Application Assessment Panel

SECTION 8.2 REVIEW OF DETERMINATION REPORT

ITEM No.	D2
FILE No.	DA27/2024/1
ADDRESS	5 Vivian Street BELLEVUE HILL
SITE AREA	559.8m ²
ZONING	R2 Low Density Residential
PROPOSAL	Installation of a new privacy screen to be installed along part of the eastern side boundary
TYPE OF CONSENT	Local development
COST OF WORKS	\$7,500.00
DATE DA LODGED	17/01/2024
DATE DA DETERMINED	21/03/2024
DA DETERMINATION	Refusal
SUBJECT OF REVIEW	Refusal of application
DATE S82A LODGED	01/05/2024
APPLICANT	Mr C Schulman
OWNER	Mr G A Oshry
REVIEW OFFICER	Mr V Aleidzans
TEAM LEADER	Mr G Fotis
SUBMISSIONS	Two (2)
RECOMMENDATION	Refusal

The proposal involves a new privacy screen to be installed along part of the eastern side boundary.

Image 10: Site plan excerpt showing maintenance of view corridor

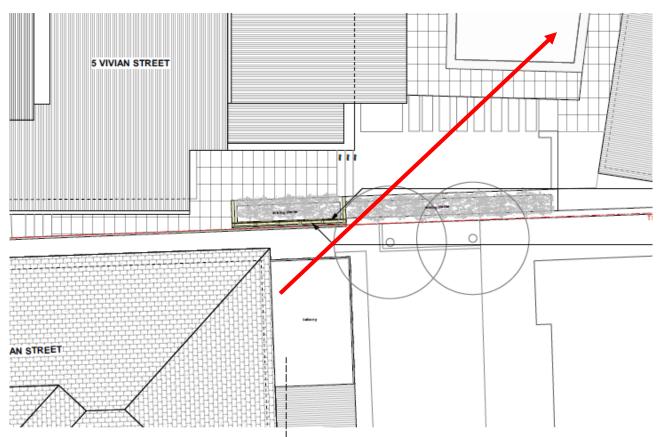
Views from No. 3 Vivian Street will be impacted by the proposal. It is considered that a part of the land, water and whole view would be interrupted from both the internal living area an adjoining balcony from both a standing a sitting position, however, it is acknowledged that this view is currently obstructed by landscaping. All of the views are located across the side boundary which the planning principle accepts as being often unrealistic to retain. Majority of the view corridor would be maintained which includes land, water and whole views from both a standing a sitting position.

In light of the above and given the nature of the affected views the impacts can be qualitatively described as minor.

Table 2 – Impact on views obtained from 3 Vivian Street towards the subject site

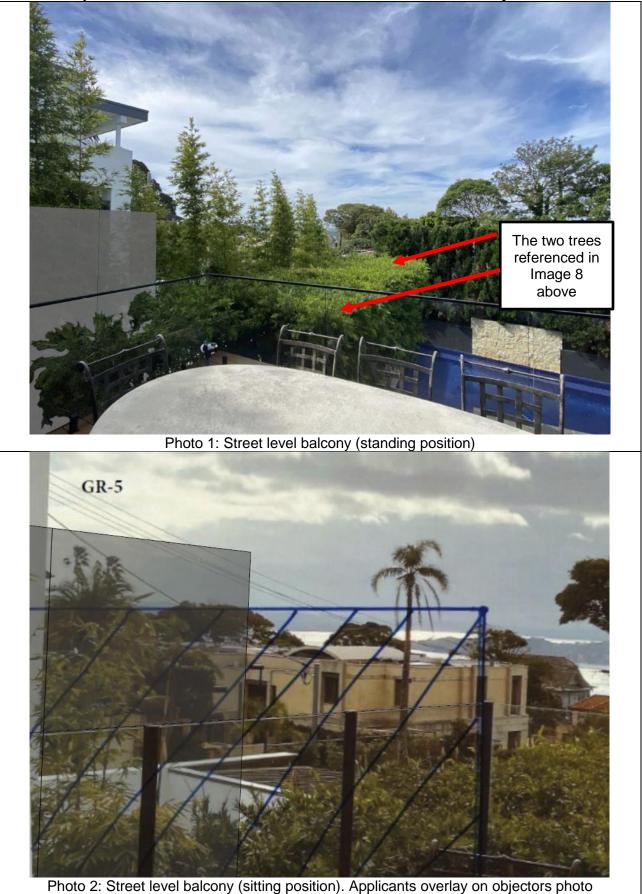
In response to this, although there are some non-compliances with respect to the Woollahra DCP 2015, these are not considered to be significant with regards to view loss and are not considered to be of a nature that would adversely alter the qualitative findings of this assessment noting the impacts are deemed minor.

The proposal is not a complying development nor are the impacts considered moderate. Therefore, the second question under Step 4 regarding a skilful design as is applies to view impacts is not considered necessary.

Overall, having regard to the relevant considerations under Part B3.5.3 of the Woollahra DCP 2015 and the planning principle established by *Tenacity Consulting v Warringah (2004) NSWLEC 140*, the proposal is considered acceptable with respect to view loss.

Image 11: View from first floor kitchen window toward No. 3 Vivian Street, Bellevue Hill

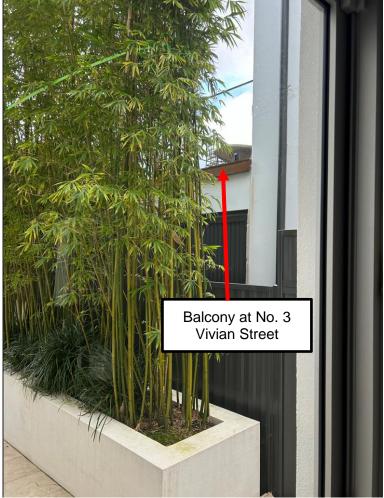
The proposed privacy screening outcome is considered the third most desirable by C4 as evident above. In this instance the windows of concern and those which the applicant has nominated as necessitating the proposed screen are deemed to already achieve (a) and (b). The first floor kitchen window and ground floor glazed bedroom door are both orientated over the rear of the subject site as oppose to across a side boundary. Furthermore, these windows are setback behind the building alignment (including balcony) of the adjoining property of No. 3 Vivian Street. This is deemed a suitable offset which limits views between buildings. Therefore, the proposed screening outcome is deemed to an excessive response based on the current relationship and having regard to C4. The images below demonstrate the current view lines obtained from the kitchen window and ground floor glazed bedroom door toward No. 3 Vivian Street.

Image 12: View from ground floor bedroom glazed door toward No. 3 Vivian Street, Bellevue Hill

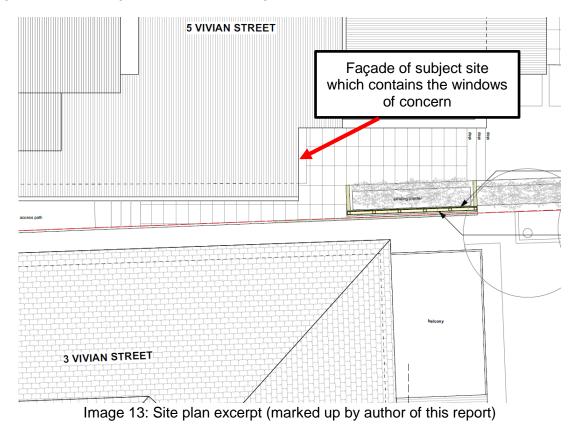
Control C6 requires that architectural design solutions and screening devices referred to in C4 (c) above are integrated with the overall design and contribute to the architectural merit of the building, having particular regard to:

As detailed throughout this assessment report the proposed screening outcome would not provide a reasonable balance of amenity between the two properties and is not considered to be a favourable architectural outcome. O2 is not upheld.

Table 2 – Extent of view loss from 3 Vivian Street Bellevue Hill

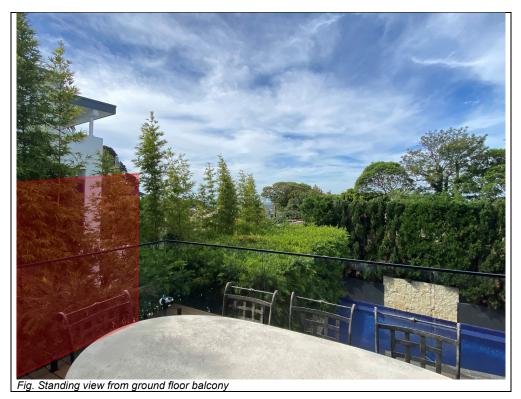
The third step is to assess the extent of the impact. This should be done for the whole of the property, not just for the view that is affected. The impact on views from living areas is more significant than from bedrooms or service areas (though views from kitchens are highly valued because people spend so much time in them). The impact may be assessed quantitatively, but in many cases this can be meaningless. For example, it is unhelpful to say that the view loss is 20% if it includes one of the sails of the Opera House. It is usually more useful to assess the view loss qualitatively as negligible, minor, moderate, severe or devastating.

The impact on views currently afforded by No. 3 Vivian Street will arise as a result of a significant noncompliance with a planning control relating to the height of side boundary fencing and is considered unreasonable. The fencing height non-compliance will be discussed in detail in Part 10.3.3 of this report.

In this instance, it is considered that the view impact could reasonably be avoided by a more considered design that retains the amenity of the proponent, such as screens to the windows within the subject site, whilst limiting the impact upon the neighbouring property at No. 3 Vivian Street.
